Rose Intimates Ltd.

Baroipara, Ashulia, Savar, Dhaka, Bangladesh
(24.021676N, 90.243656E)

8th and 21st January 2019

Observations

Slab outline

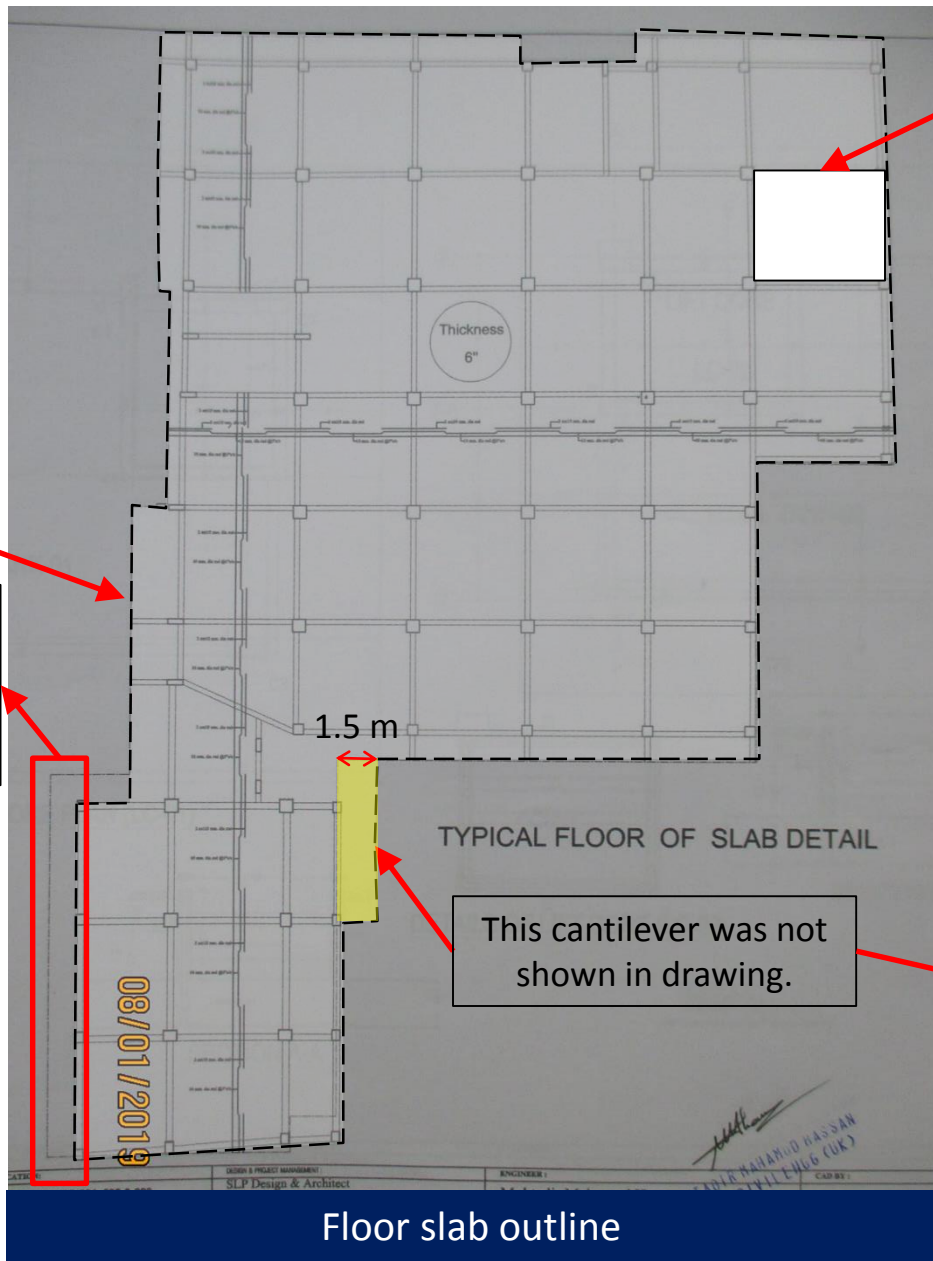
The slab layout (cantilever) of this building was not matched with provided drawings.

There was no cantilever in the marked portion but shown in layout drawing.

No barrier found on 5th floor

There was a void at 1st floor level (over loading/unloading zone) but shown in slab layout.

This cantilever was not shown in drawing.

Slab outline

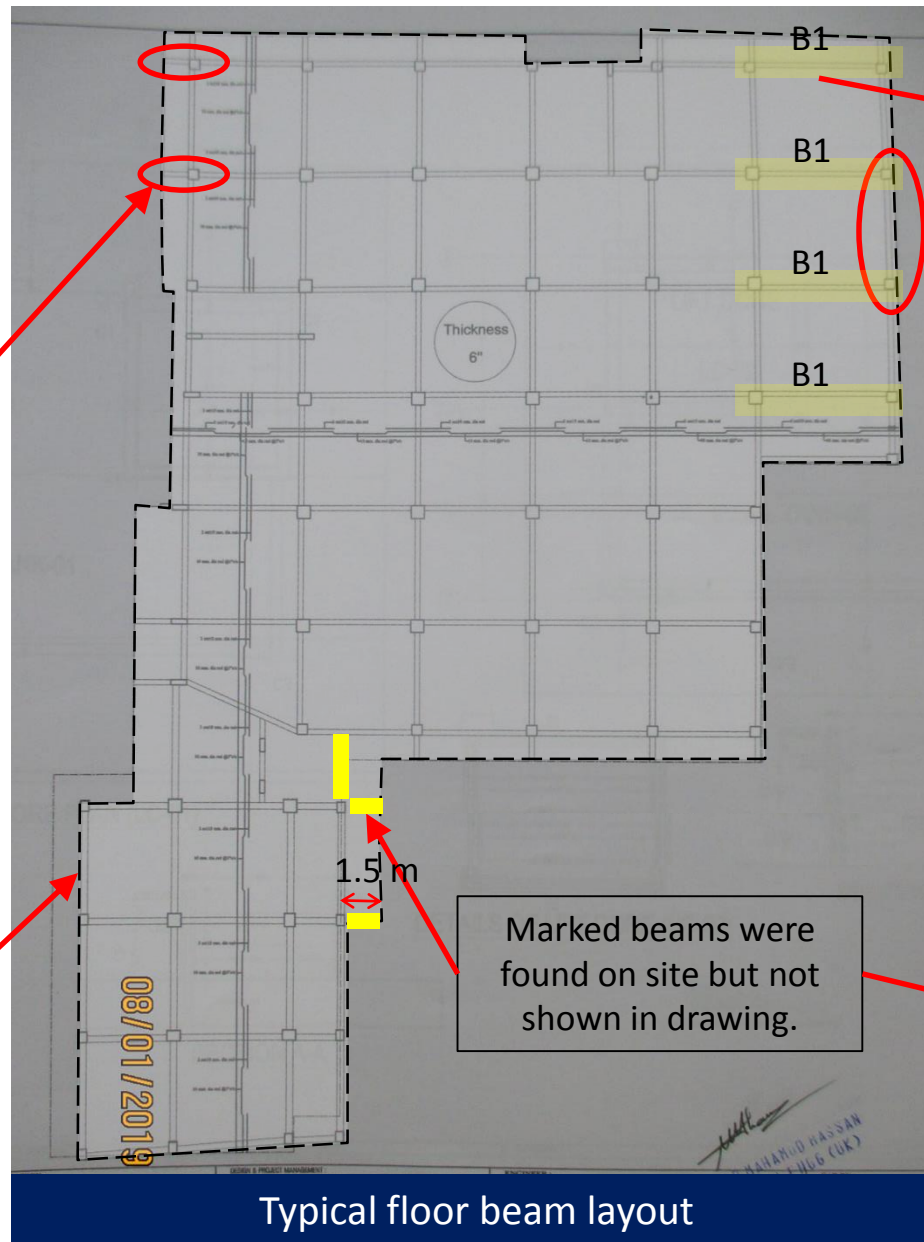
The floor beam layout of this building was not matched with provided drawings.

There was no cantilever beam on site but shown in drawing.

Beam B1 (300x600mm) was found instead of B2 (300x750mm) in the marked locations.

There was no beam in the marked portion at 1st floor level but shown in drawing.

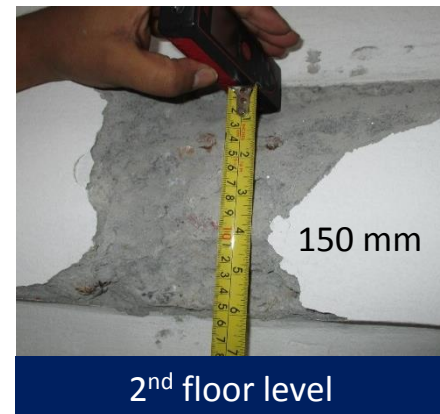
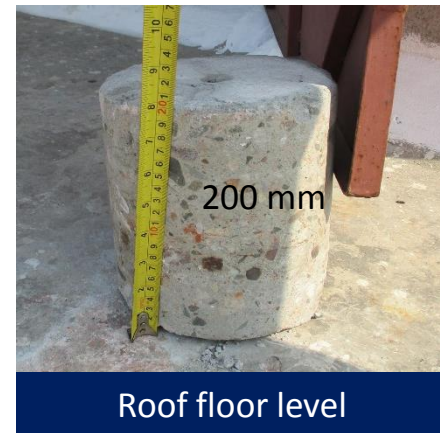
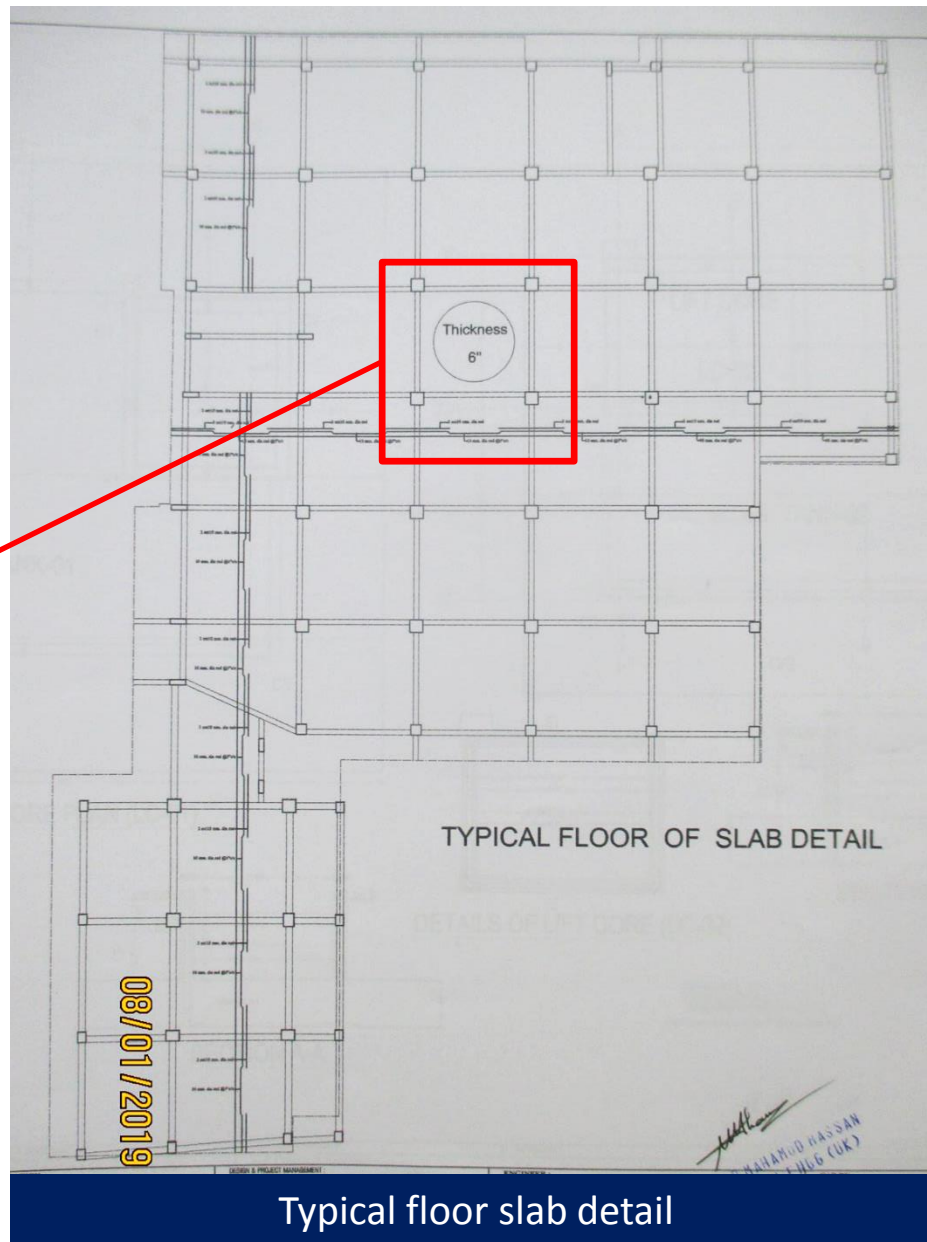
The floor slab thickness was not matched with provided drawings.

150mm (6") slab thickness was shown in drawings. But it varies floor to floor from 150mm to 200mm.

Column Layout

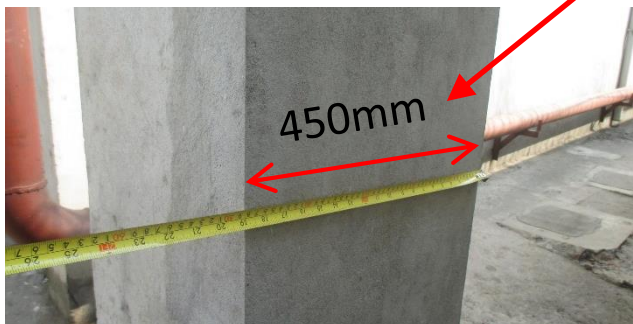
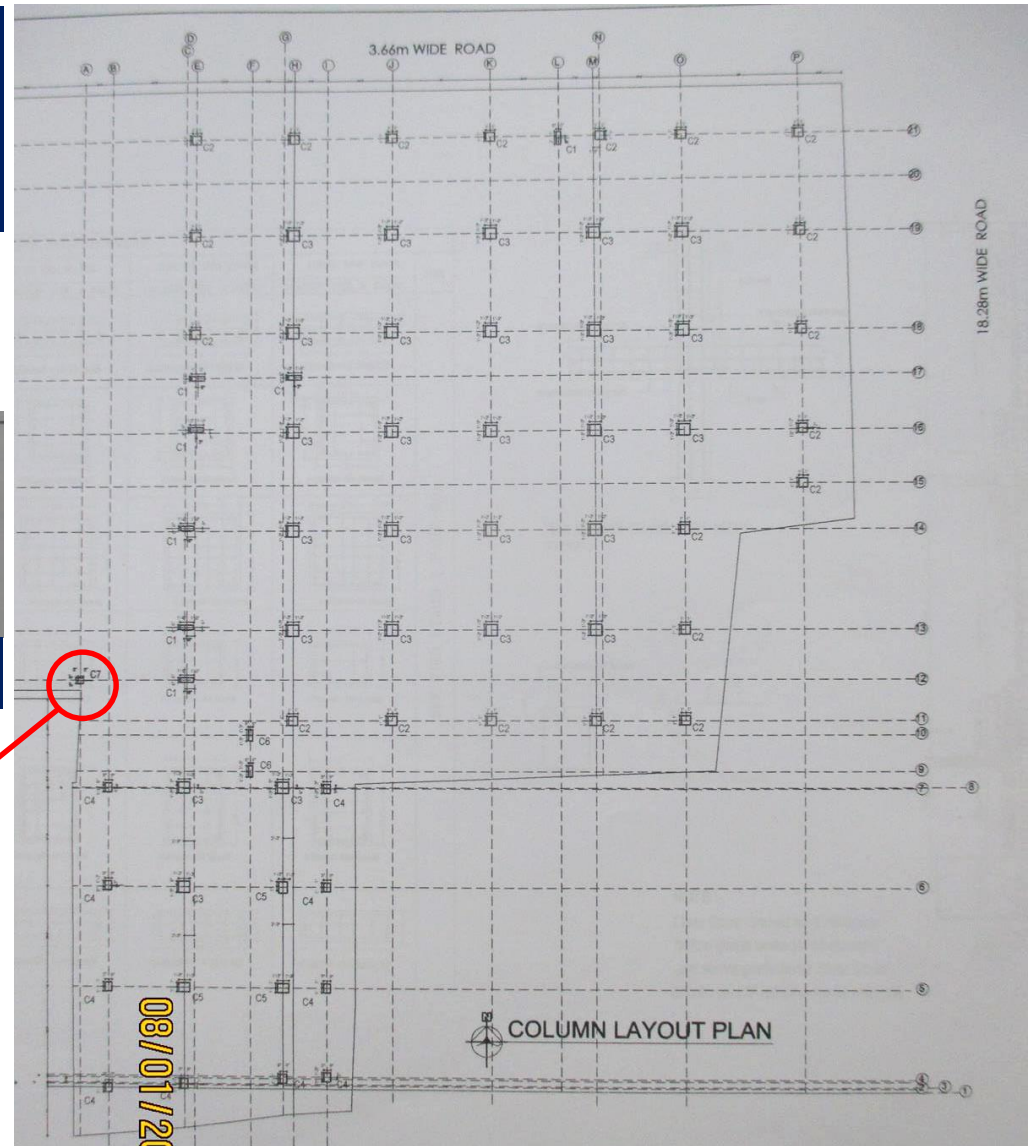
The size of C7 column was measured 300mmx 450mm instead of 300mm x 300mm. Also, 10 number rebar was found instead of 12.

Roof top load plan

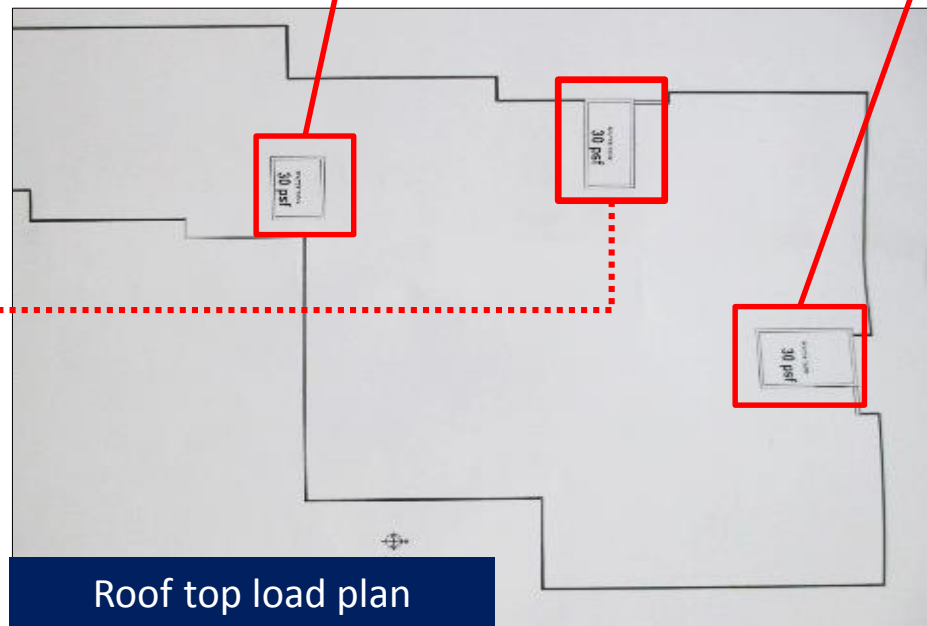
On the roof level, there three RC over head water tanks were shown whereas only one RCC water tank was found on the marked location. In addition, no roof top detail was found in as-built architectural drawing.

Roof top layout in load plan

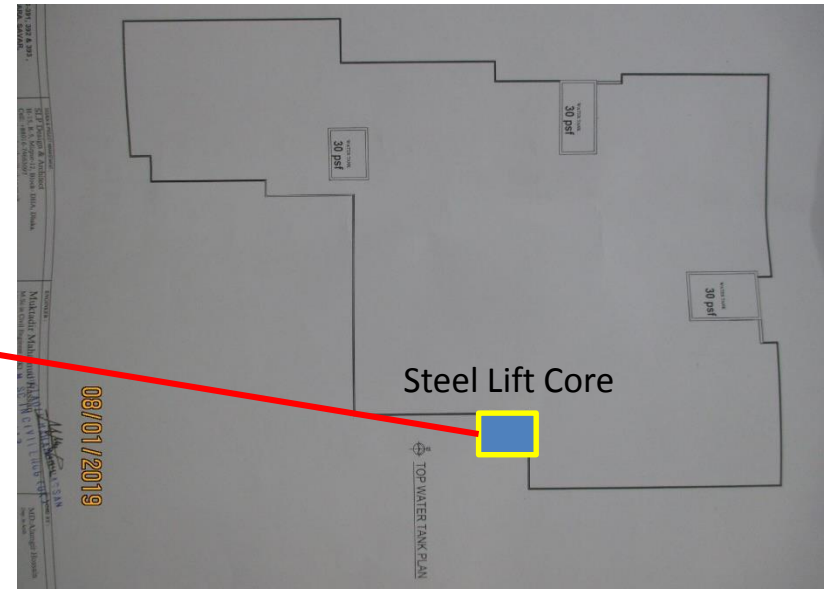
A steel stair adjacent to main factory building have no architectural and structural details.
The connection between main building and steel stair seems to be non-engineered.
Structural redundancy of vertical member not to be verified.

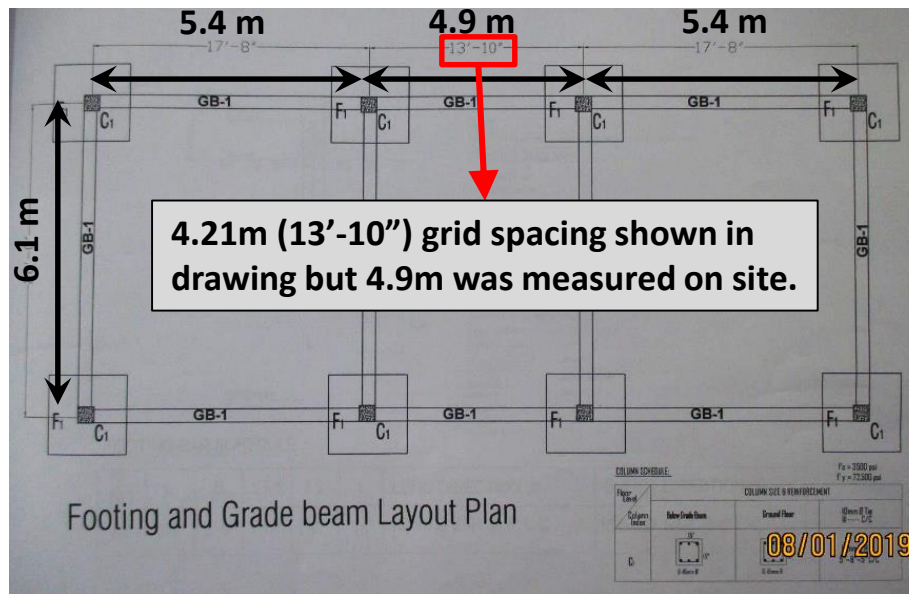
No barrier and signage was observed to protect the columns in loading-unloading zone which are susceptible to vehicle impact.

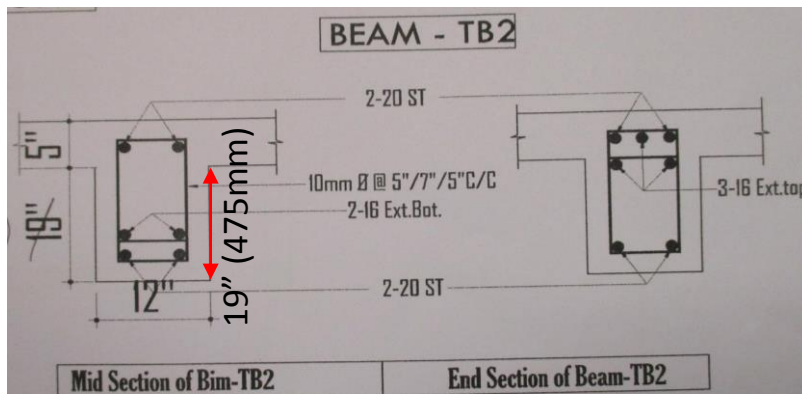
The grid spacing of Doctor's and Child-care building was not similar with provided drawings.

Column & beam layout

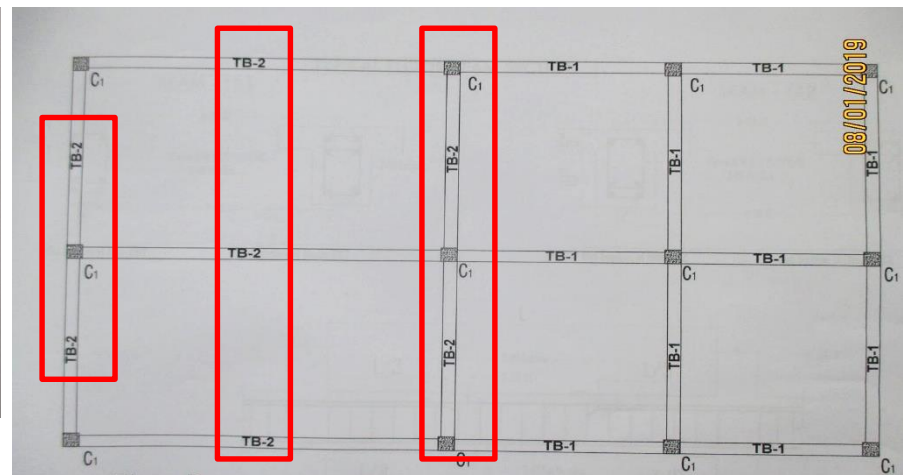
On site, down stand of TB-2 was measured 425mm (17") instead of 475mm (19").

Also, column schedule and grid spacing of generator building was not available in the drawings.

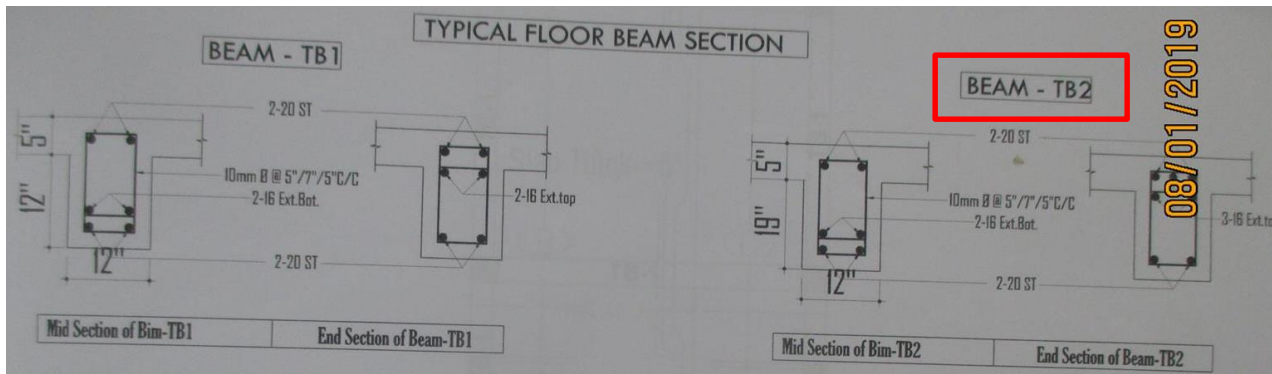
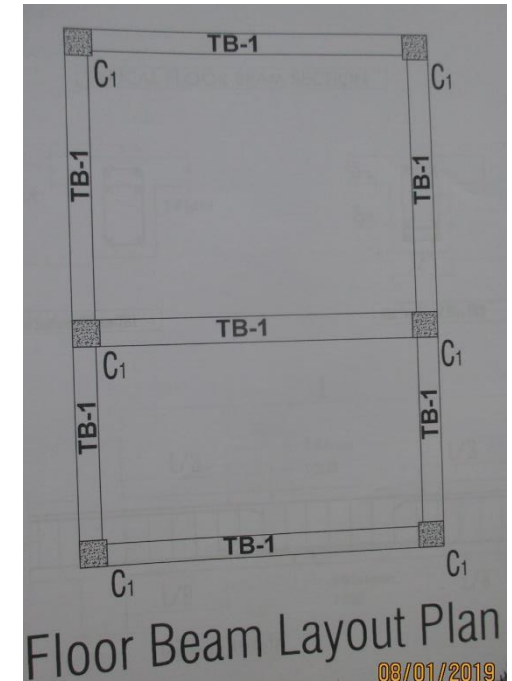
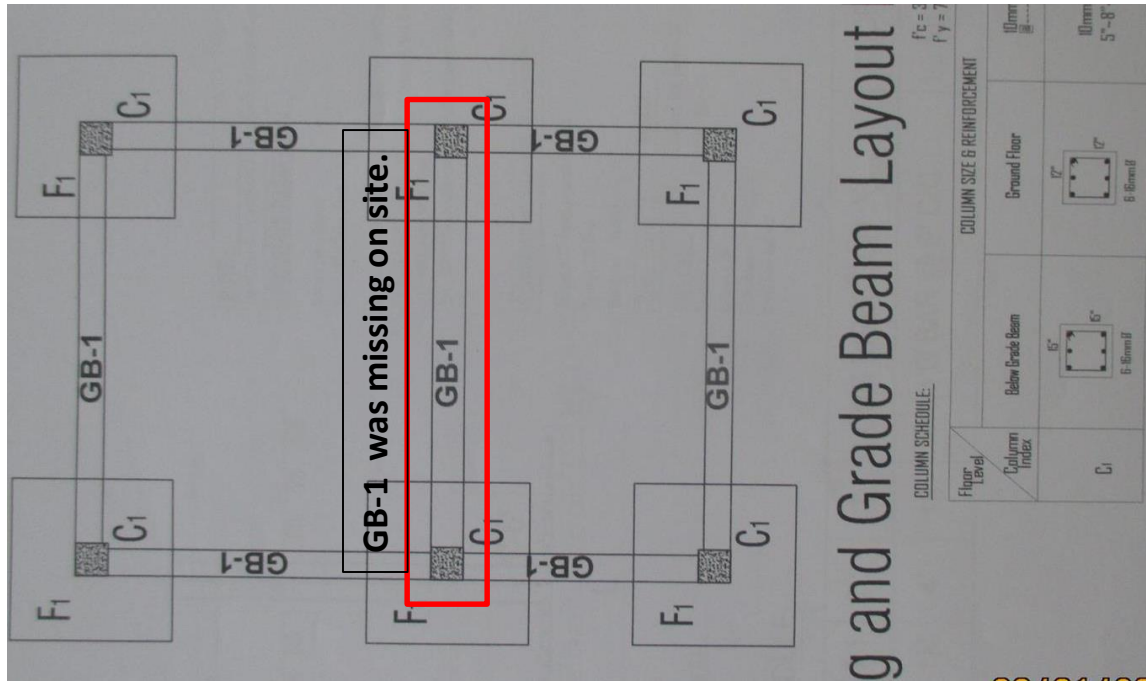
TB-2 beam was not found in beam layout as well as on site

The column grid spacing of Fire pump building was not shown in provided drawings. Also, internal grade beam was not found on site. There is no TB2 beam but shown in drawing.
